National Trust submission relating to the Development Application for MLC Building, 105-153 Miller Street, North Sydney (DA 387/2024)

The National Trust of Australia (NSW) welcomes the opportunity to provide feedback regarding the development proposal for the MLC Building North Sydney. We note that the building is listed on the National Trust of Australia (NSW) Register, NSW State Heritage Register, North Sydney LEP, Docomomo NSW Modern Register and the Australian Institute of Architects Register of Significant Buildings in NSW.

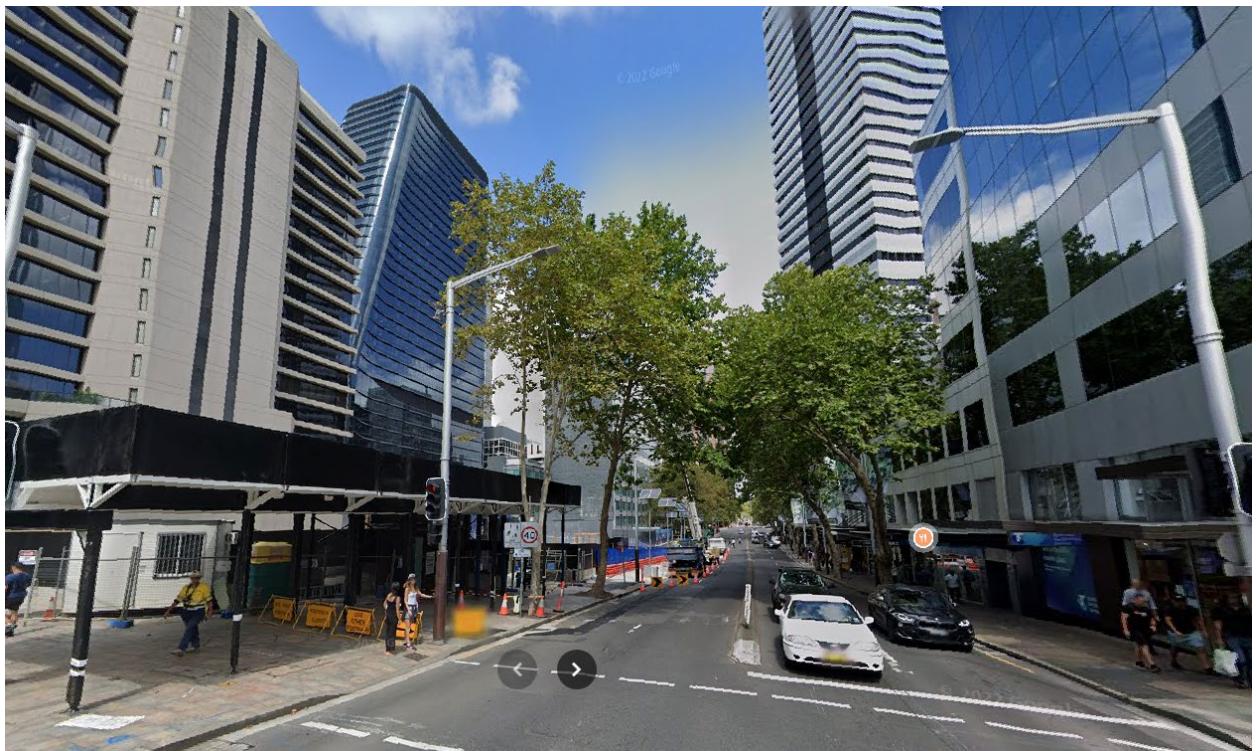
- The artistic impression of the proposed development (below) uses a blue transparent outline to represent the impact of the new core. This should be represented as a solid mass.
- The key viewpoint from the North Sydney Post Office which has been selected is so oblique that even the massive new building at 1 Denison Street is hardly visible in the assessment – and in the artistic impression it appears to have been removed entirely.
- The key view of the site from the intersection of Miller Street and Berry Street has not been included in the assessment.

Artistic impression of the new building, with the new core represented by a translucent sky-blue shape, misrepresenting its true impact. Note also that No.1 Denison Street appears to have been completely airbrushed out, but with the adjacent new towers over the Metro Station still under construction fully illustrated.

By focussing the visual impact assessment on such a small radius around the building, the National Trust consider that the true impact of the proposal on the historic building has been disguised. The Trust would call for the visual impact assessment to be undertaken again.
